PROPOSAL FOR CODE CHANGE

FOR OFFICE USE ONLY		
Received	8/15/2018	Code
		2018 IRC
		Proposal number
		# 169

Code title		Edition
International Residential Code		2018
Section number and title		Page number
M1301.2 Identification		
Proponent	Representing (if applicable)	
Phil Gettum	Gettum Associates	
Address (number and street, city, state, and ZIP code)		Telephone number
		()

Figure 3: Fenestration U-factors from HERS-rated homes, 2014-2016

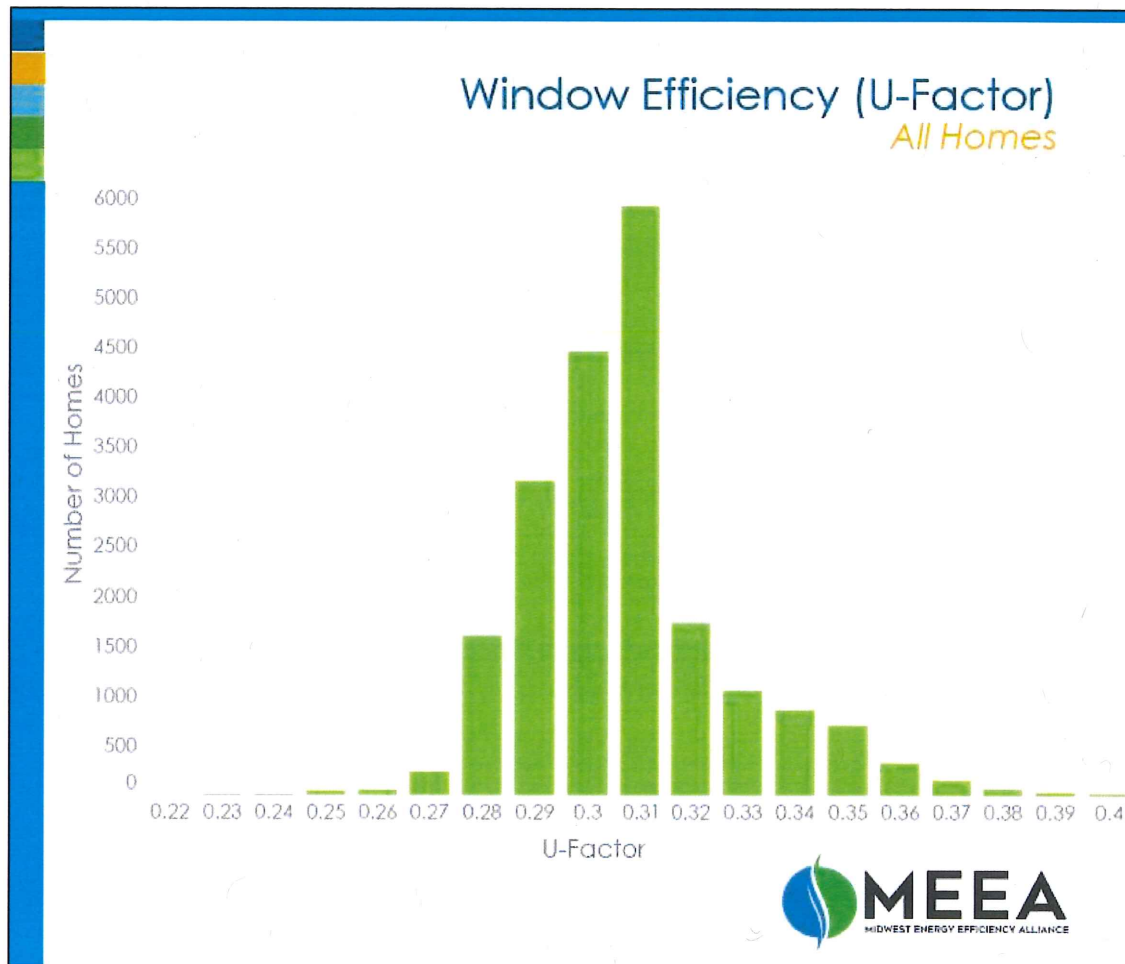
Recent analyses show that Indiana homebuilders are already routinely exceeding the fenestration requirements of the 2018 IRC. The Midwest Energy Efficiency Alliance recently worked with RESNET to collect data on roughly half of all single-family homes built in Indiana from 2014-2016 (20,446 homes).¹ The data show that even though Indiana currently only requires 0.35 U-factor windows, **84% of the windows being installed in these homes meet a 0.32 U-factor and that almost half of the windows installed meet a 0.30 U-factor.** Figure 3 shows a summary of the results.²

Revise Tables N1102.1.2 and N1102.1.4 to incorporate 2018 IRC fenestration U-factors. See RECA-MEEA Attachment 1 for underline/strikethrough changes and additional information.
